SAFETY RECALL

Date	Number	Release	Page
10.2015	RVXX1503	01	1 (10)

Draglink Rod, Replacement

VAH

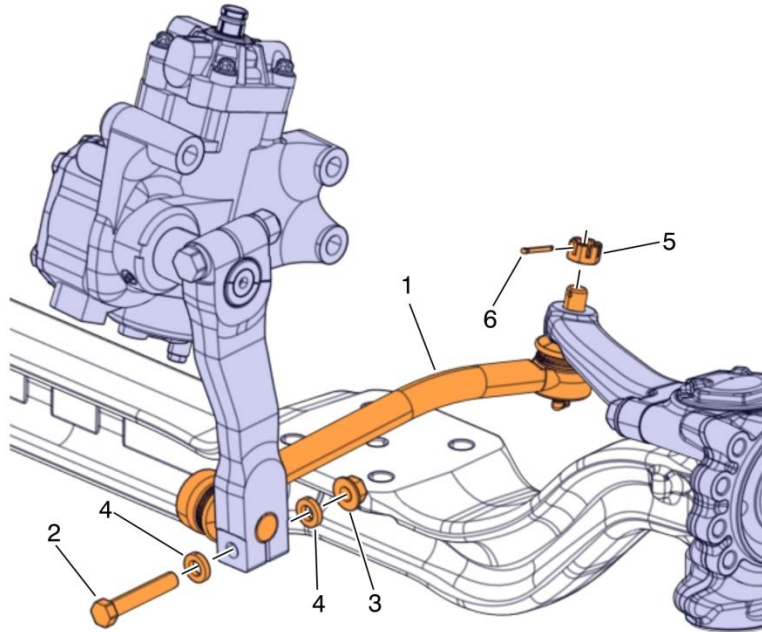
VOLVO Trucks North America has determined a defect relating to motor vehicle safety may exist in certain VOLVO VAH trucks manufactured between 02/08/2012 and 05/28/2015. The draglink rod boot may tear and enable dirt/dust to contaminate the draglink rod ball socket on some VOLVO VAH trucks. Replacement of the existing draglink rod with a new angled draglink rod (part number 22667930) for VAH trucks is necessary to prevent solid contamination of the draglink rod ball socket. The mounting hardware should be replaced with new mounting hardware each time the draglink rod is replaced. Follow the repair procedure outlined in this Safety Recall.
